UPDATE PRIOR TO SALE NOTICE

Global Service Action
Number: N845 UPS6023-3

Subject: Oil Cooler Pipe Joint Integrity Concern	Publication No.: N845 UPS6023-3
	Model: Range Rover (LK)
	Model Year: 2024
	Model: Range Rover Sport (L1)
	Model Year: 2024
	Date of Issue: 17 November 2023
	Expiry Date: 17 November 2024

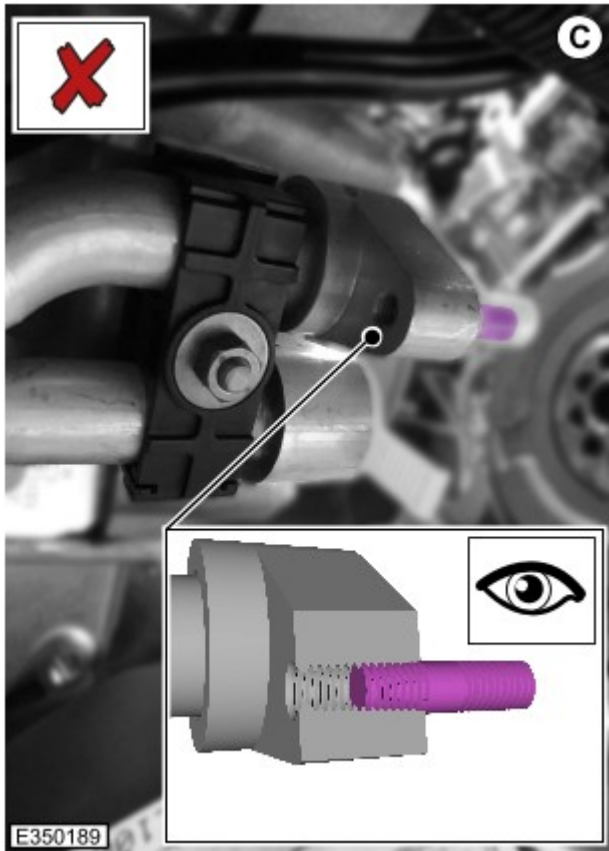
- The image labeled 'A' shows a reworked engine oil cooler pipe with a suitable bolt installed through the joint from the rear of the vehicle.
- The image labeled 'B' shows a new level engine oil cooler pipe with a suitable stud installed through the joint from the rear of the vehicle. The stud can be seen from the rear of the joint.
- The image labeled 'C' shows an previous level engine oil cooler pipe with a stud installed into the joint from the front of the vehicle. The stud cannot be seen from the rear of the joint.
- Use a suitable mirror to inspect the rear of both engine oil cooler pipe joints.

Inspect the fixings/studs on both engine oil cooler pipes.

- If **BOTH** engine oil cooler pipes **ARE** installed with **EITHER** the reworked fixing or the new level stud shown in the image 'A' and 'B' with a **GREEN '✓'**, the vehicle has **PASSED** the inspection. Reverse steps 1 to 3 and release the vehicle.
- If **1 or BOTH** engine oil cooler pipes **ARE** installed with a previous level stud as shown in the image 'C' with a **RED 'X'**, the vehicle has **FAILED** the inspection. Continue to the **SERVICE INSTRUCTION**. To renew the previous level studs that have failed the inspection.

E350135

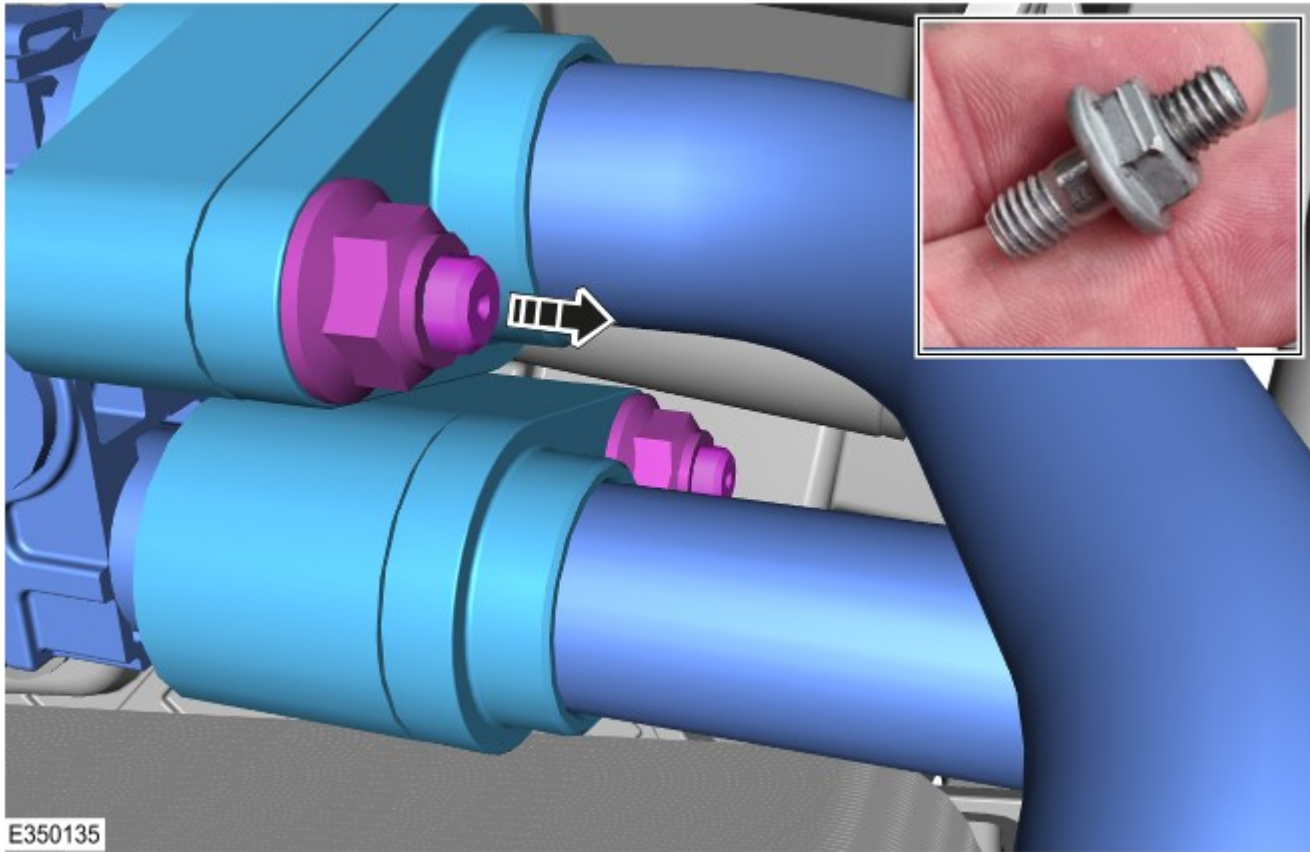
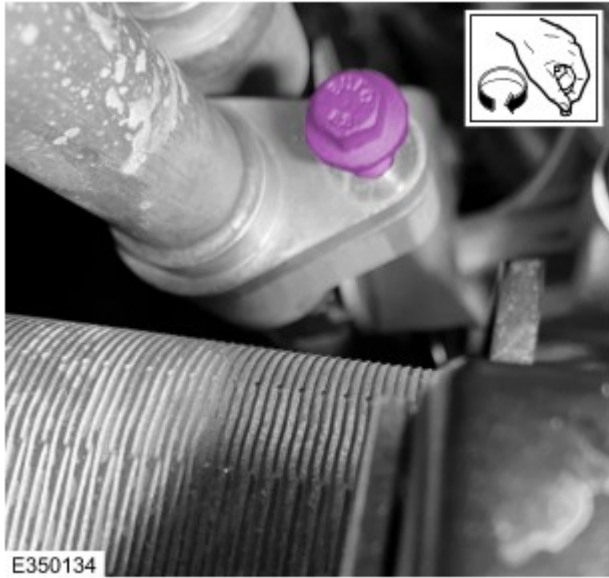
Do not allow the oil cooler pipes to separate during this step. Failure to follow this instruction may result in loss of engine oil.

The stud should release from the engine oil cooler pipe during the removal of the nut.

Remove the nut/stud assembly.

- If a stud cannot be removed from an engine oil cooler pipe when removing the nut **OR** a stud snaps during removal, **DO NOT** continue with this SERVICE INSTRUCTION. Email JLRcamp@jaguarlandrover.com to confirm how many studs could not be removed. Use the campaign number **N845** and the full 17 digit [Vehicle Identification Number \(VIN\)](#) as the subject of the email.
 - Continue to hold the vehicle and wait for further instructions.

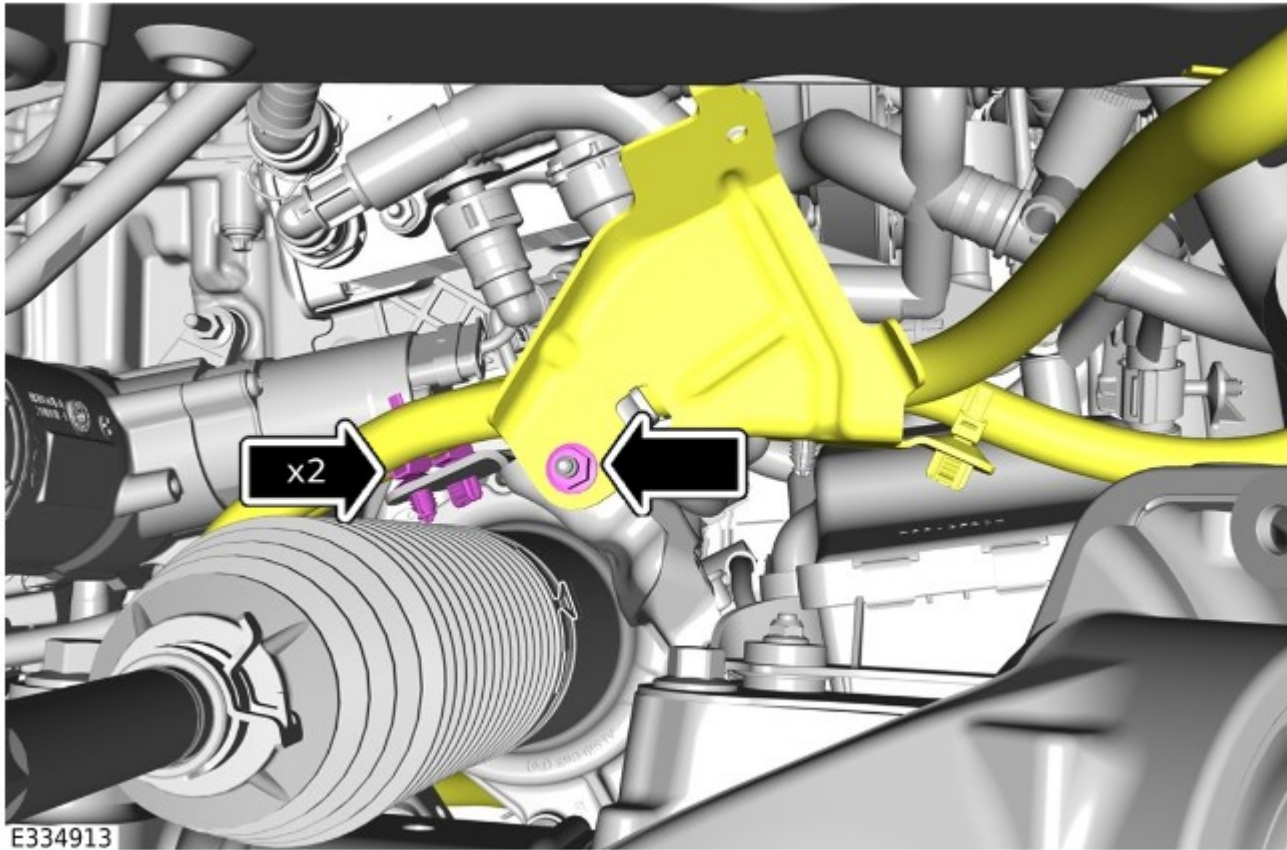
Install the new M6 x 25mm bolt into the engine oil cooler pipe from the front of the vehicle.

- Torque: **10 Nm**
- If the bolt cannot be started by hand **OR** the bolt cannot be tightened to specification, **DO NOT** continue with this SERVICE INSTRUCTION. Email JLRcamp@jaguarlandrover.com to confirm the bolt cannot be tightened to specification. Use the campaign number **N845** and the full 17 digit [VIN](#) as the subject of the email.
 - Continue to hold the vehicle and wait for further instructions.
